Comprehensive Summary

Georgetown - M Street NW and Wisconsin Avenue NW Proposed 2023 Deck Changes Compared to 2022 Permit

2023 ANNOTATED PROPOSED DECK MODIFICATIONS

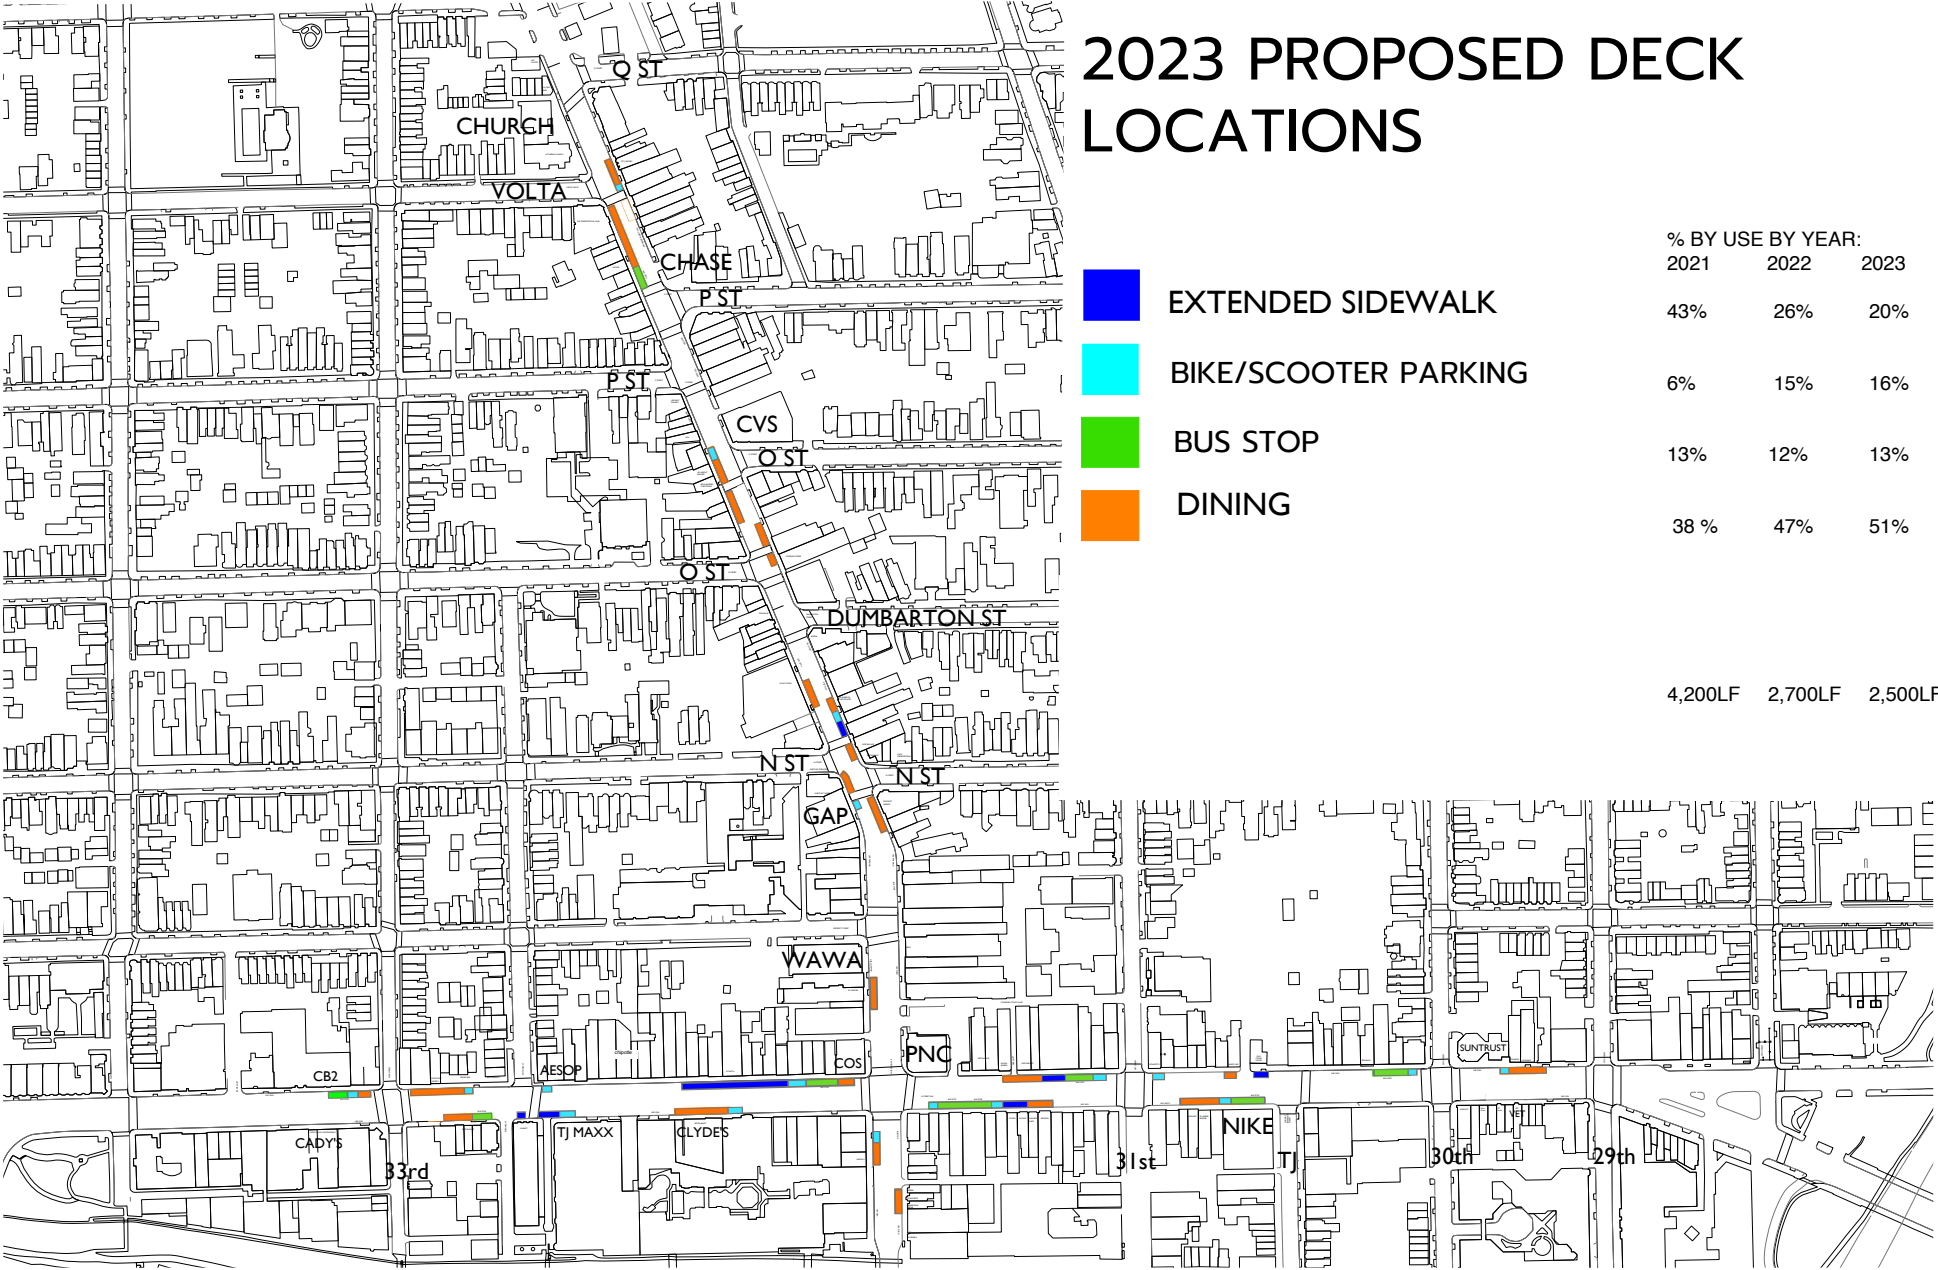
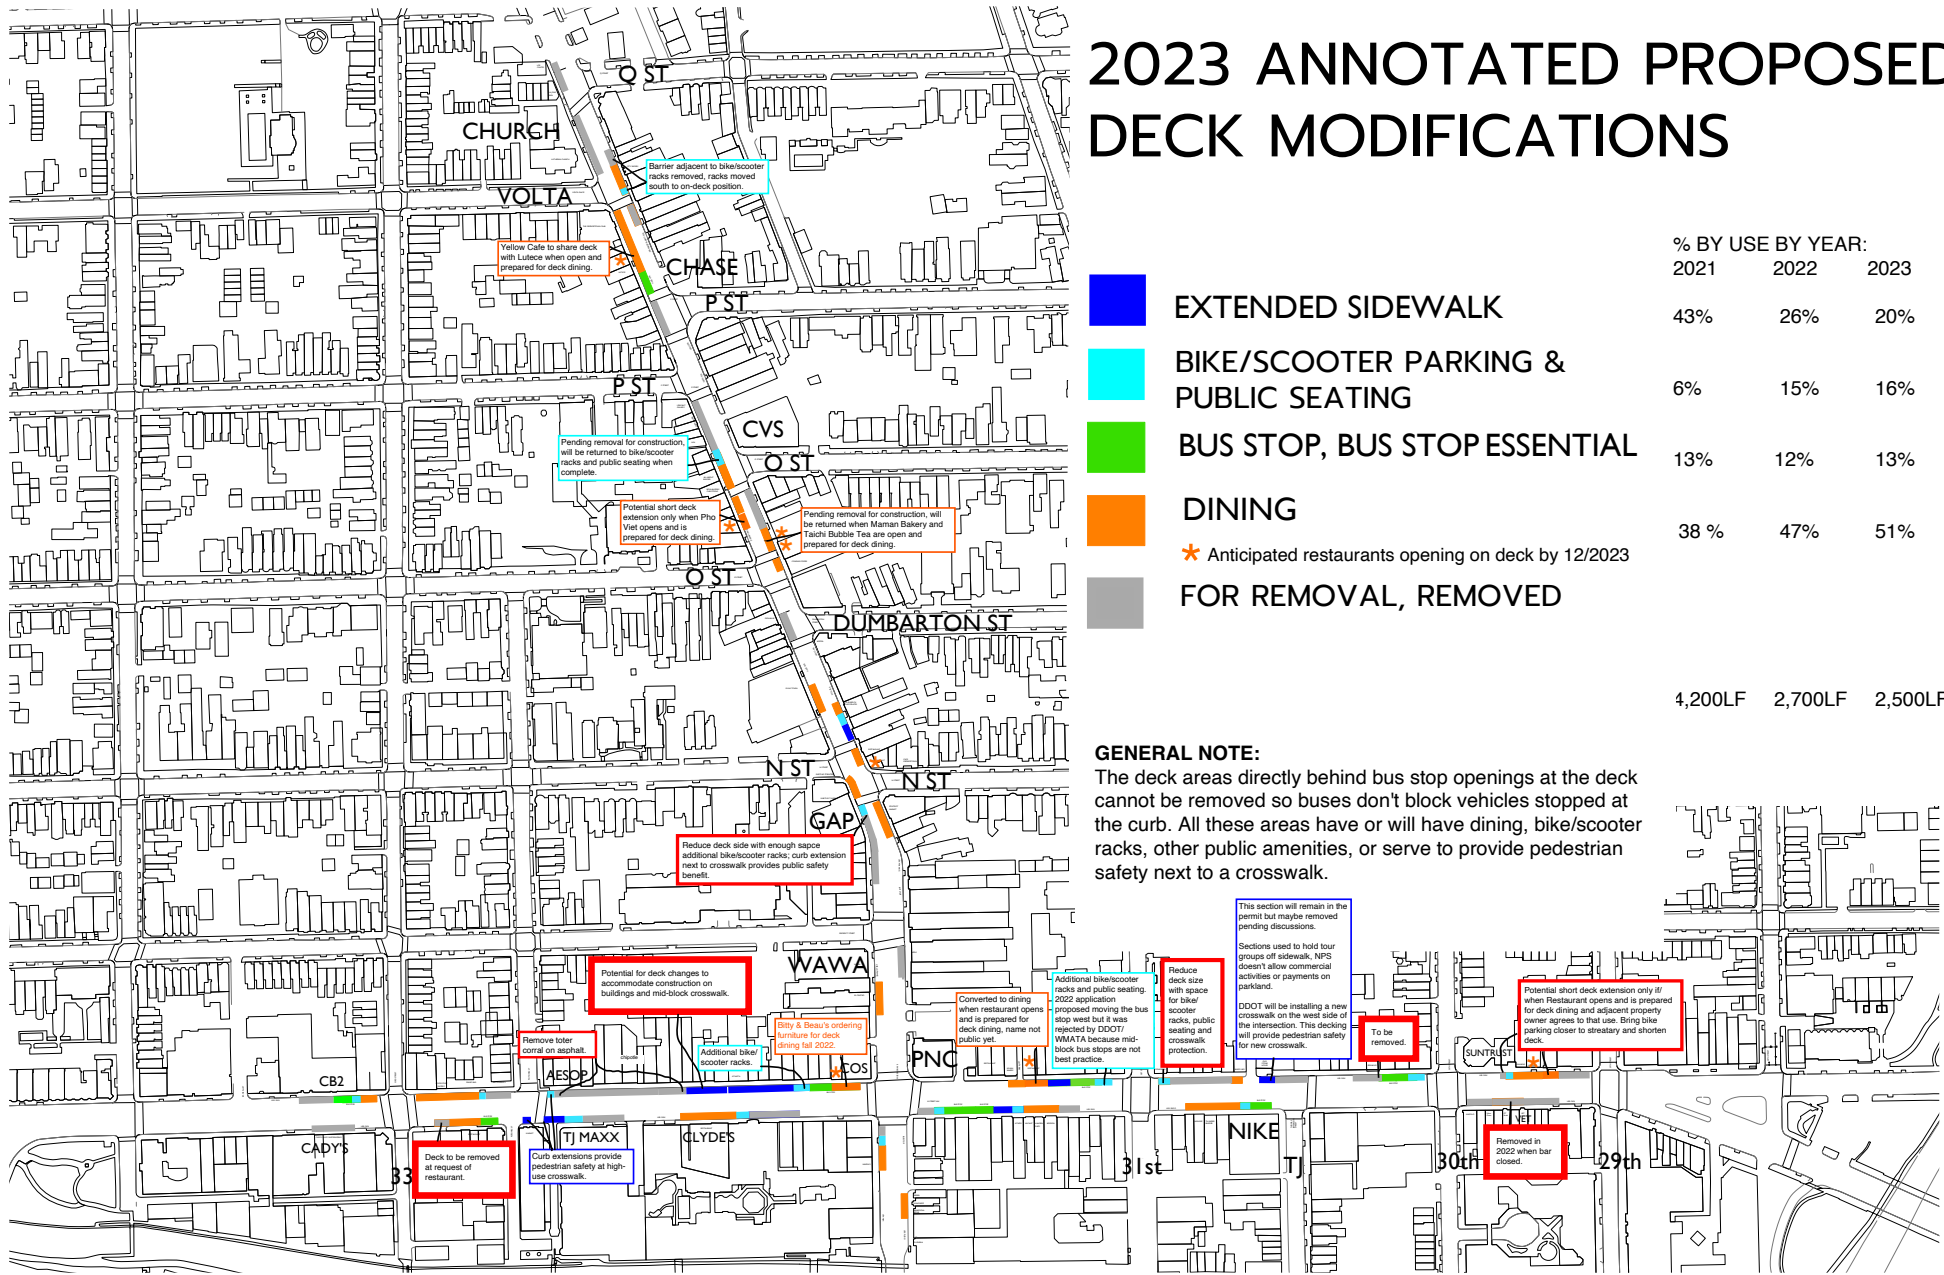
Minor changes to accommodate restaurants and future restaurants as noted below.

| SECTION | 2023 MODIFICATION PROPOSED FROM PREVIOUS YEAR | PROPOSED CURBSIDE USE |
|---------|--|--------------------------|
| 4 | Reduced on west end by 24 feet at request of adjacent business. | No parking |
| 5 | West end changed from 45 degree to 90 degree angle (no turning movement to accommodate due to one-way street adjacency); additional painted bulb-out. | - |
| 6 | Toter corral moved onto the deck; note that anticipated construction of a mid-block crosswalk and nearby building construction will result in deck reductions as needed. | - |
| 10 | Section reduced from the east end and bike racks placed on deck. | Flex |
| 18 | Reduced from west end with bike racks relocated to far east end on the deck. | Flex |
| 20 | Section added back to east end; will only be built if restaurant opens and commits to streatery operations. Reduce decking on west end of streatery by 18 ft to end at L'Annexe property line. | - |
| 24 | Bike racks on north end elevated on deck panels. | - |
| 27 | Reduce south end decking at request of the community. Short buffer will remain adjacent to crosswalk on N Street. | |
| 32 | Full section added back (originally in 2021 plans but not built); will only be built if restaurant opens and commits to streatery operations. | - |
| 36 | Section added back to north end; will only be built if restaurants open and commit to streatery operations. | - |
| 41 | Reduce on north end and relocate bike racks to south end. | Parking |
| 44 | Section added south end; will only be built if restaurant opens and commits to streatery operations. | Was bike/scooter parking |

Figure 7. Curb Bulb

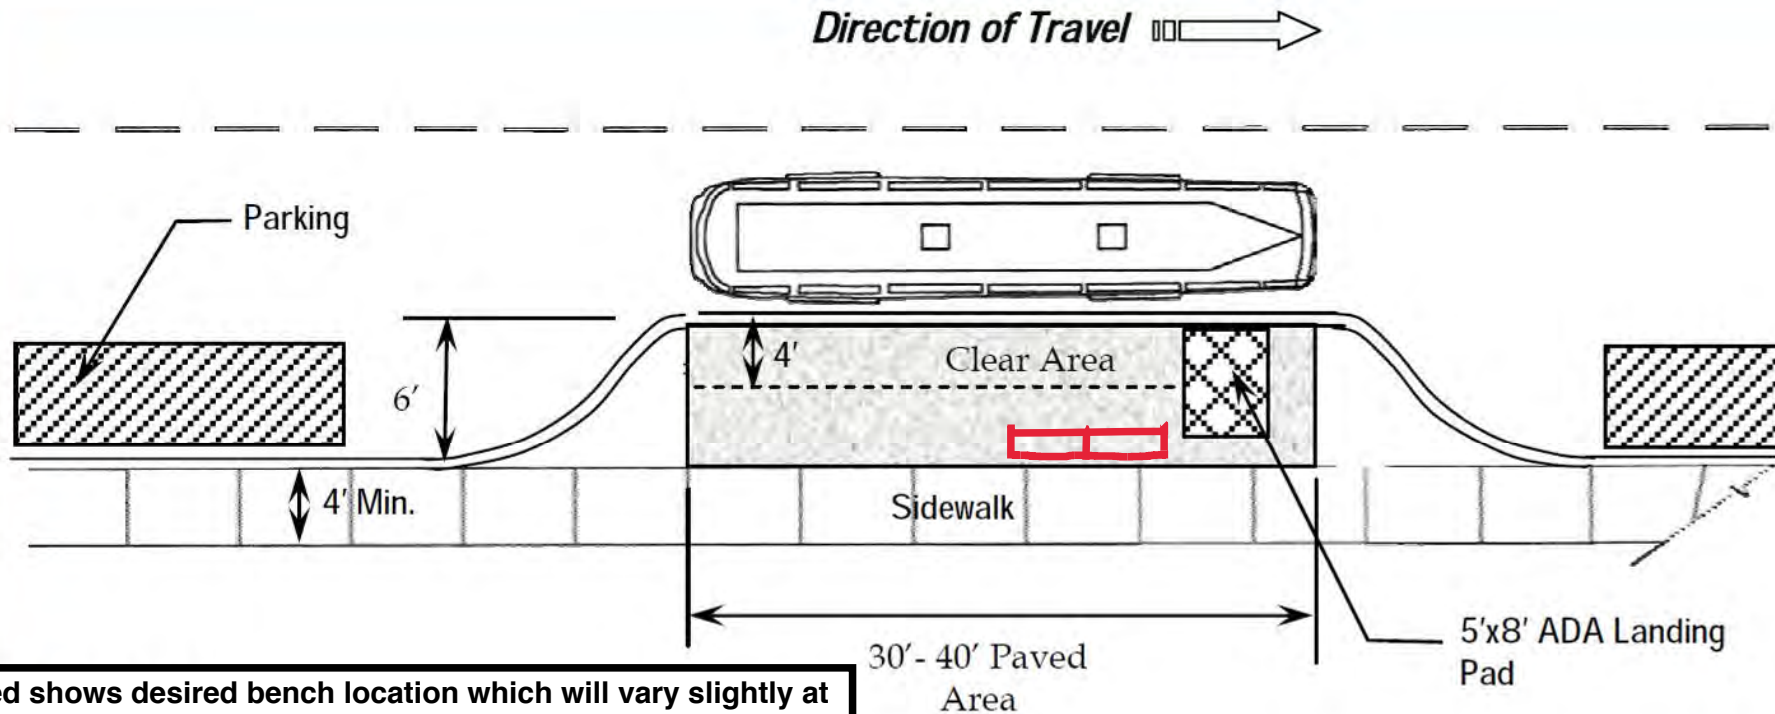
Red shows desired bench location which will vary slightly at each bus stop:

- facing the roadway
- outside ADA landing and 4' clear area
- near the curb either in the furniture/tree box zone of the existing sidewalk or on the deck, NOT in pedestrian clear zone
- thoughtfully positioned in relationship to adjacent streetscape fixtures to maintain walking paths to deck
- surface mounted and easily removable by BID contractors
